**SERVICING DESIGN BRIEF
AND
STORMWATER MANAGEMENT
REPORT**

1420 EARL ARMSTRONG ROAD

TOWN SQUARE CENTRE

**SITE PLAN APPLICATION
FILE No. DO7-12-14-0067**

SWM DRAINAGE PLAN

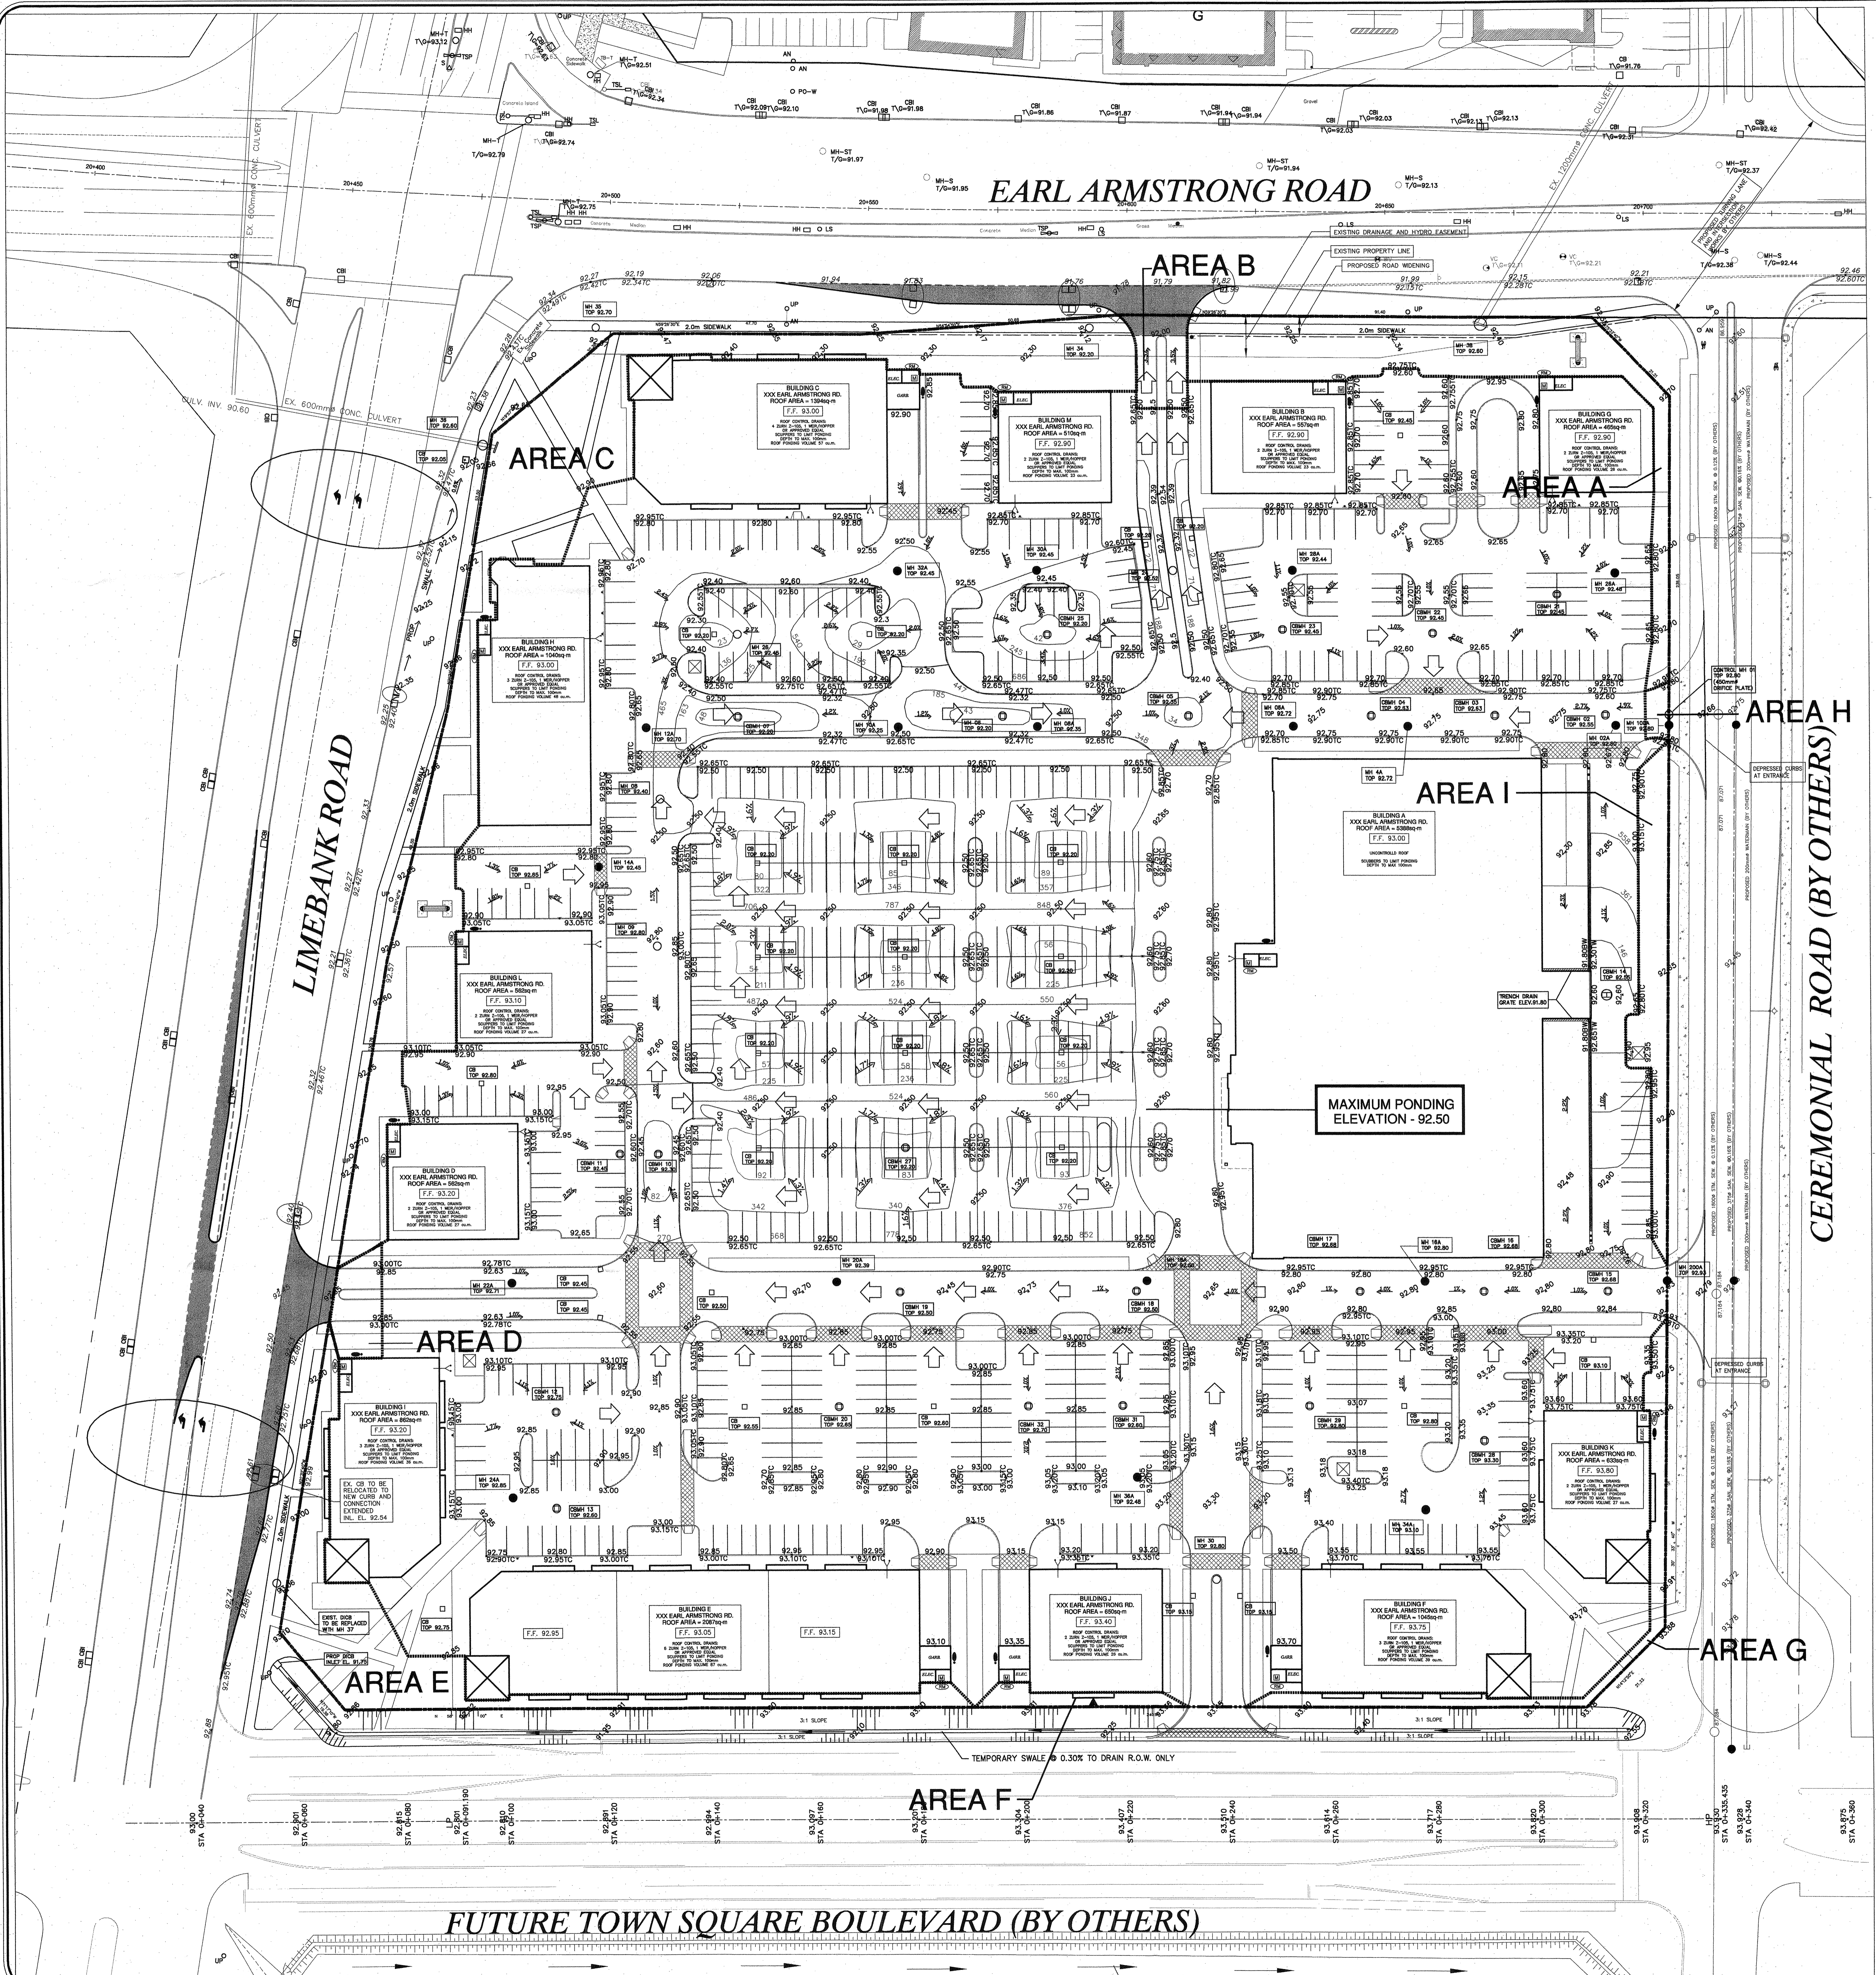
7. Engineering Drawings – Drainage Area Plan indicates Ponding Stages (i.e. 1:2, 1:5 & 1:100 ??). Show on plan what storm event(s) & what maximum ponding level is for each ponding area.

77. Please reference the surface ponding depth volume table on this plan in the SWM report.

78. Revise the ponding area at the rear of Building “A”.

Response: *The SWM Drainage Plan, Drawing No. 3 of 8, has been re-named and revised*

Response: *Noted*

Response: *Drawings has been revised*

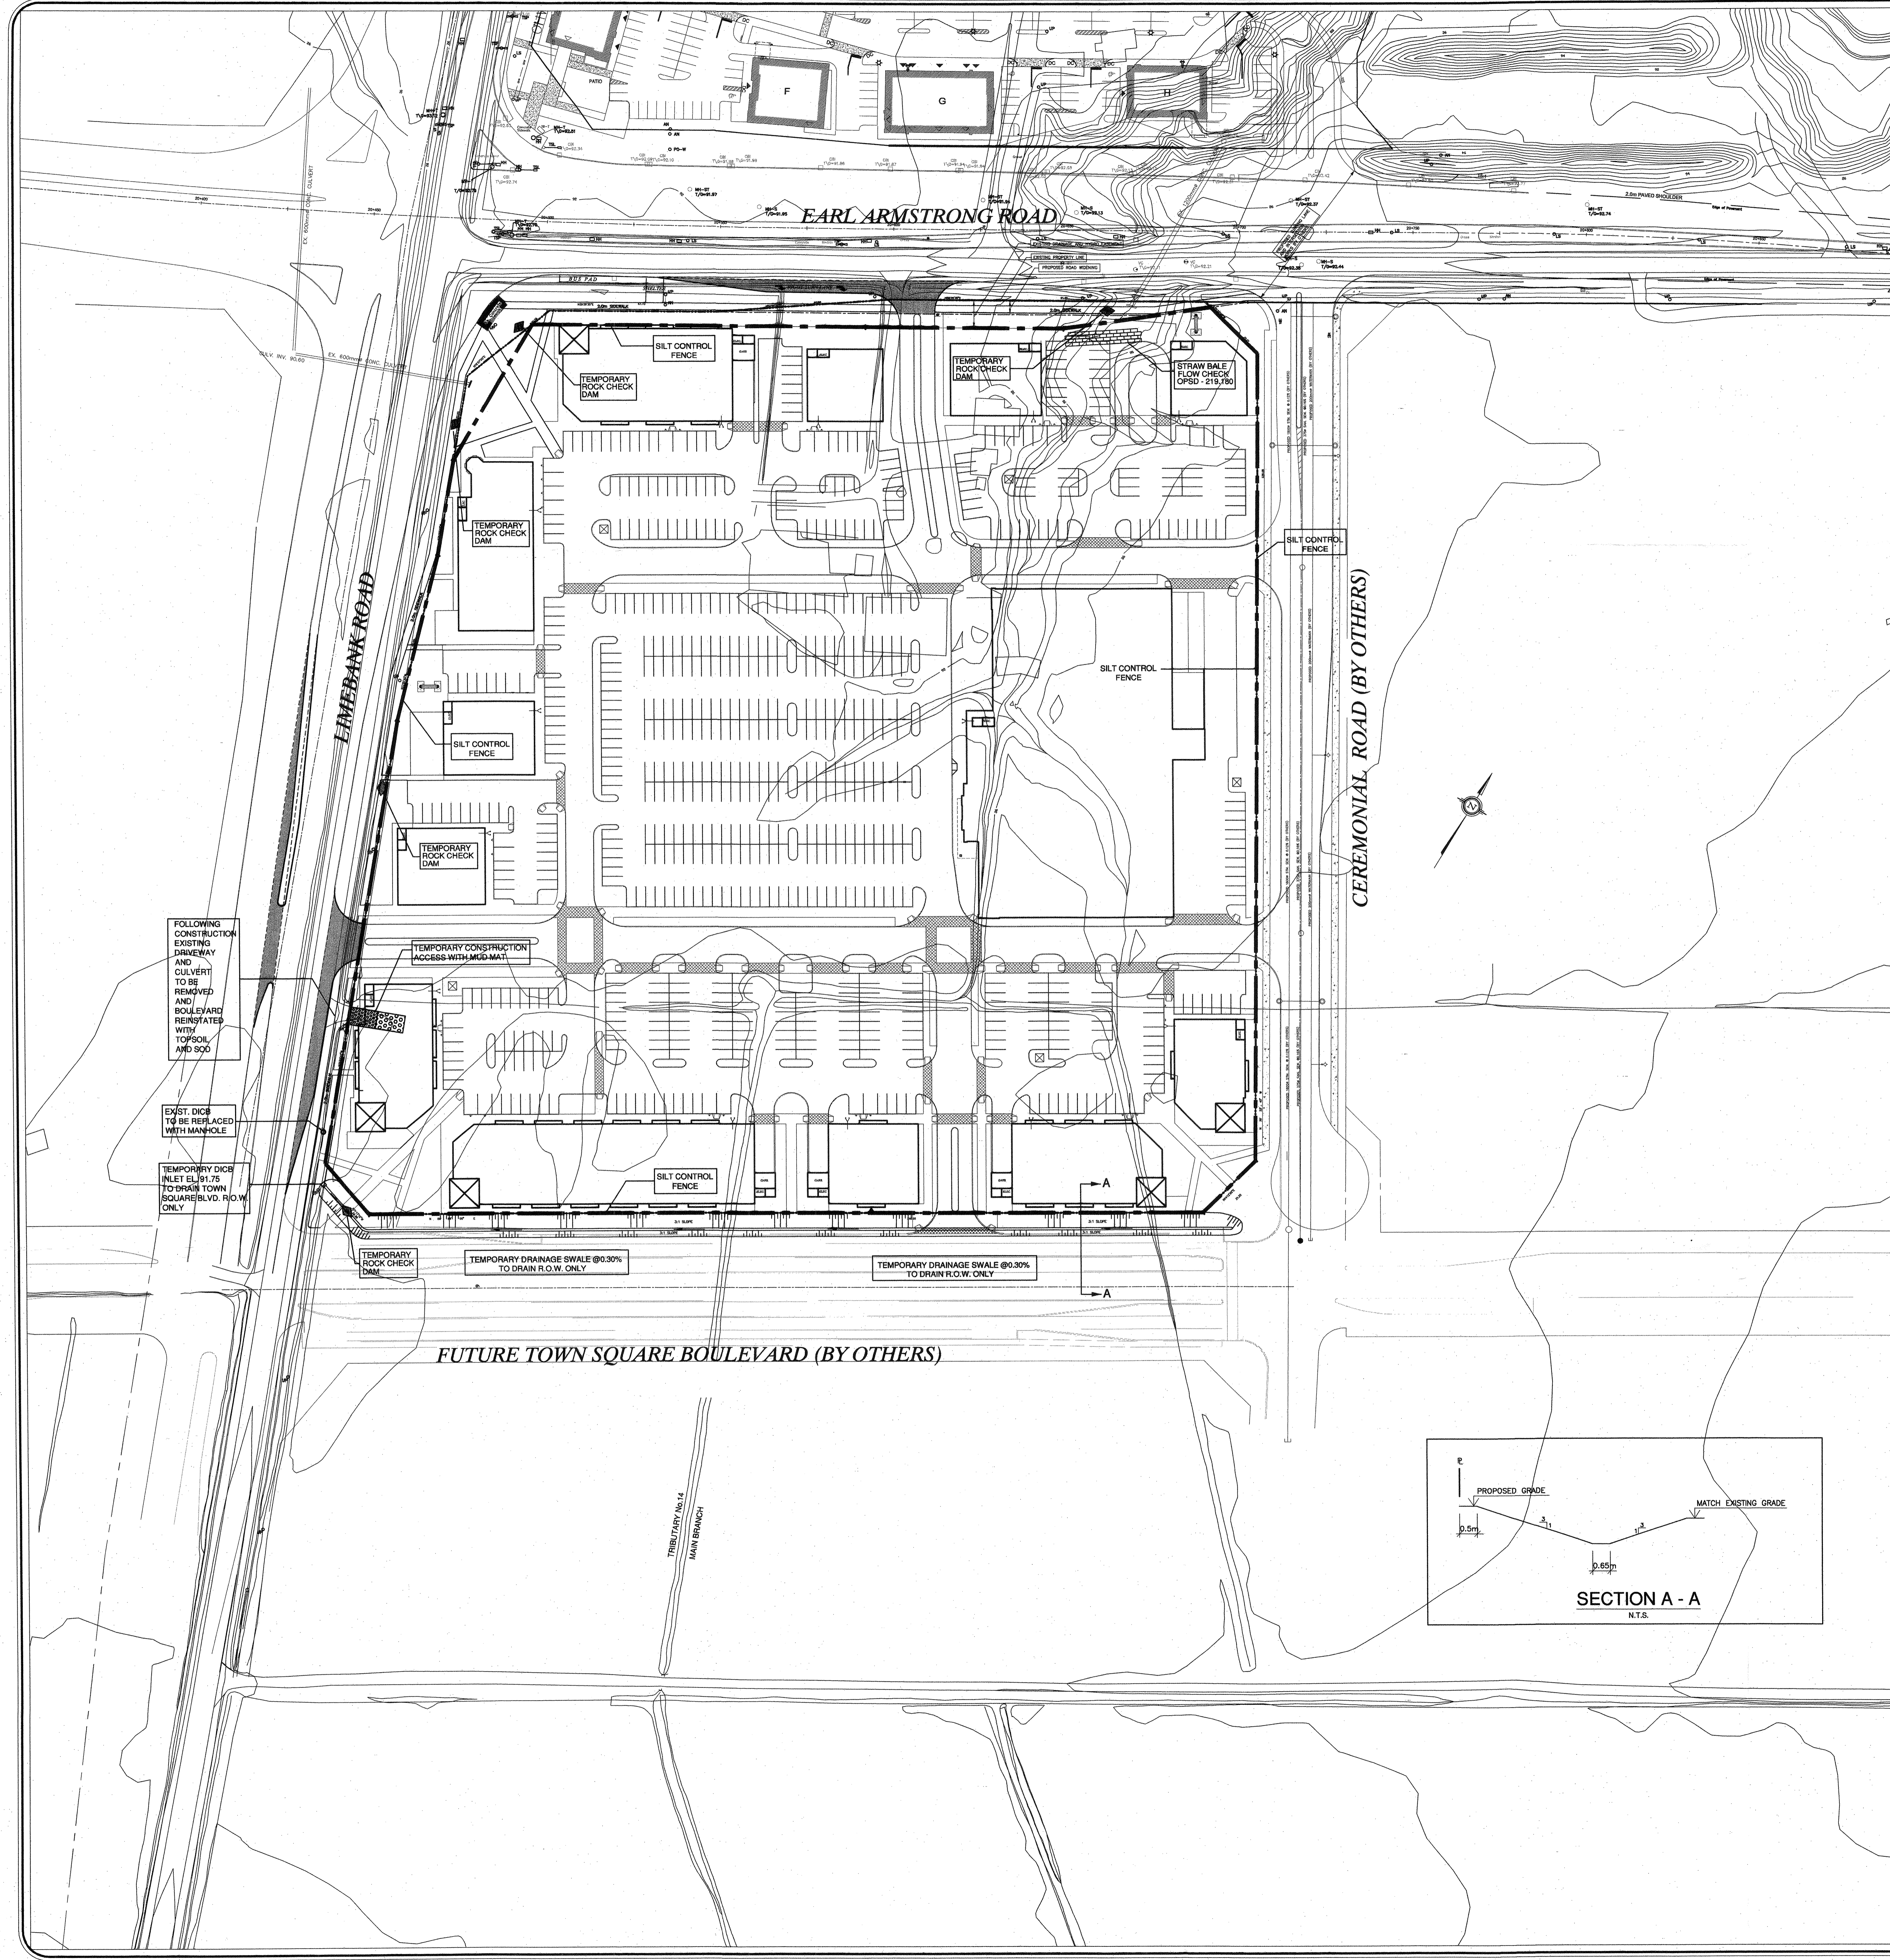
5. Erosion and Sediment Control Plan – missing Off Site Works and no off site protection shown (6 copies)

79. If this plan is to be used for off-site ditching it should be re-titled “Off Site Ditching and Erosion Sediment Control Plan.

81. Provide a minimum of 3 cross-sections of the ditch indicating the 100 year water levels; the SWM report to have supporting calculations on the ditch size/water level.

Response: *The Erosion & Sediment Control Plan, Drawing No. 4 of 8, has been updated to also include off-site work areas*

Response: *Drawing no. 8 of 8 has been re-named*

Response: *The design addressing off site drainage has been revised*
